SERVICE BULLETIN

SB No. 98 Issue No. 1

TITLE INSPECTION AND RECTIFICATION OF AIR CONDITIONING COMPRESSOR ALIGNMENT
CLASSIFICATION

T67M260-T3A Nos 2109, 2110, 2123 to 2158. ⁶⁹
INTRODUCTION:

Fig 1
View on Front of Engine

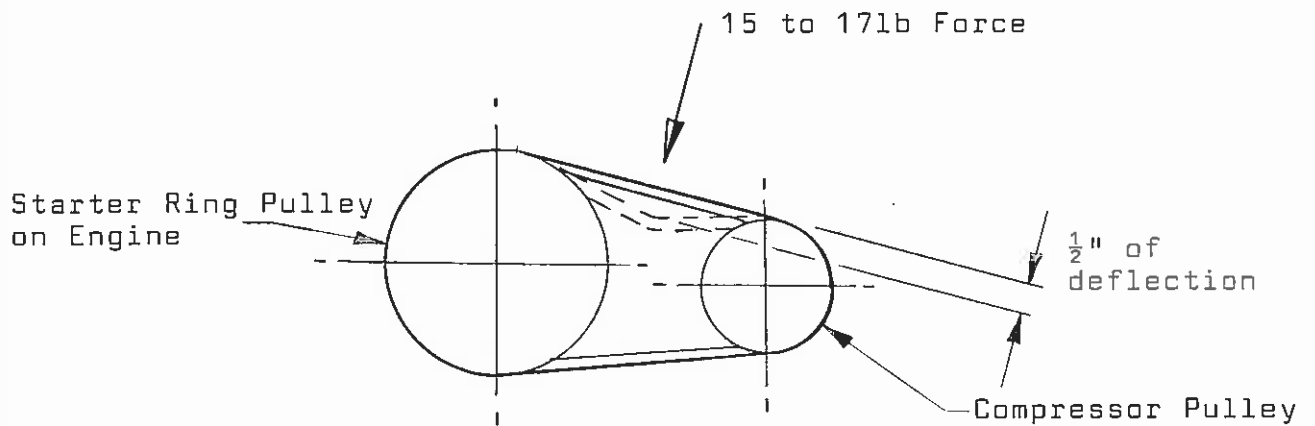
1. Prior to checking alignment of compressor, the belt tension and mounting bracket should be set up as follows. Set drive belt tension to give 1/2" deflection at mid span on top side of belt with a force of 15 to 17lb. Refer to paragraph 4 for tensioning instructions. Ref. Fig. 1.
2. Check behind compressor mounting bracket for shim Pt No. T67G-74-521. If fitted, record in log book SB 95 complied with. If no shim is fitted, proceed as paragraph 4 and subsequent.
3. Check compressor alignment as follows:

Fig 2
Plan View on Engine

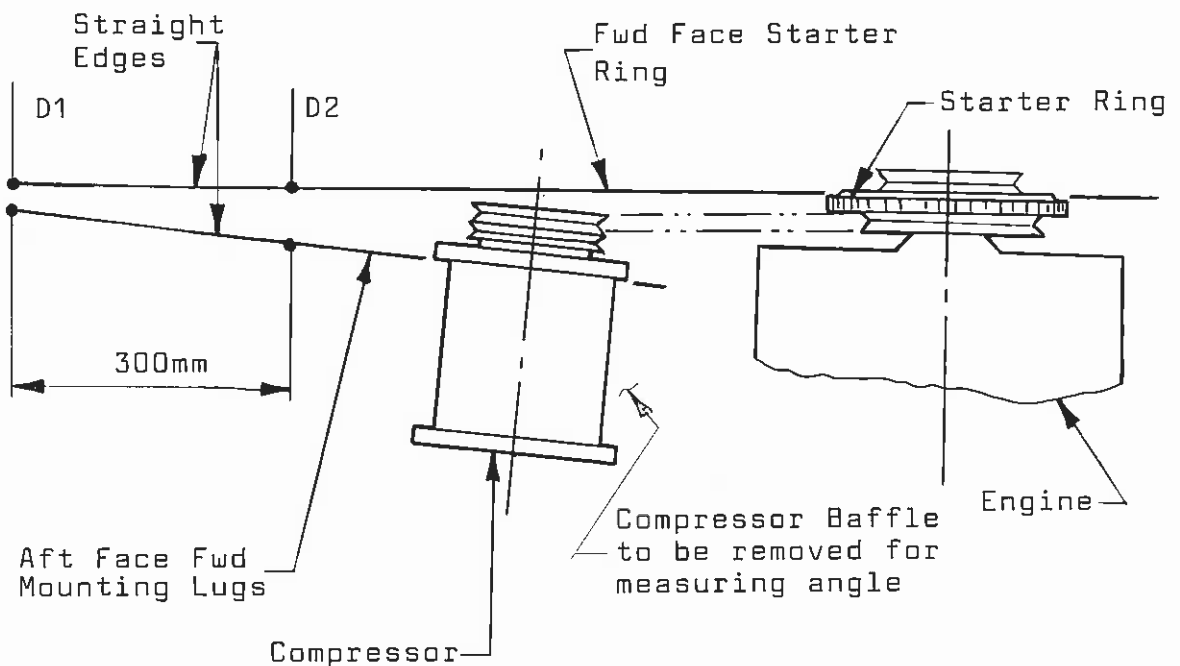
With the belt correctly tensioned, Ref paragraph 1, measure the angular alignment of the compressor using straight edges, Ref. Fig. 2.

The maximum compressor mis-alignment allowed is $1^{\circ}-08'$ or $D2-D1 = 6\text{mm}$ maximum. (D1 & D2 measured over 300mm). Ref. Fig. 2.

If the angle is greater than $1^{\circ}-08'$ or dimension greater than 6mm then angled shim Part No. T67G-74-521 should be fitted as shown in Fig. 3.

Fig 4
Showing Method of Tensioning

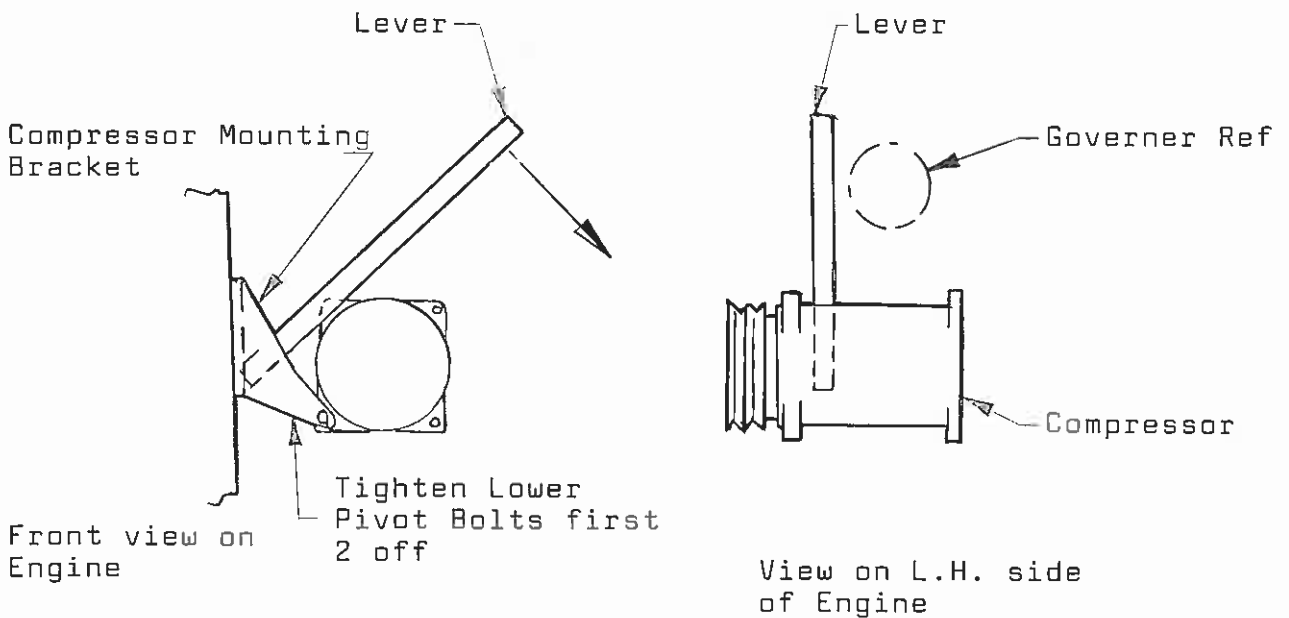
Insert a suitable size piece of wood between the compressor mounting bracket and the compressor body towards the front of the compressor. Lever the compressor outwards to tension the drive belt. When the correct tension is achieved fully tighten the lower two pivot bolts. While maintaining the tension with the wood lever, tighten the pivot arm bolt on the compressor. Check the tension on the belt and if adjustment is required re-tension as described above. Re-check tension and ensure all fasteners are secure. Ref. Fig. 4.

With the belt correctly tensioned, the compressor will be pulled approximately 0°-23' (2mm over 300mm) out of alignment in addition to any other mis-alignment.
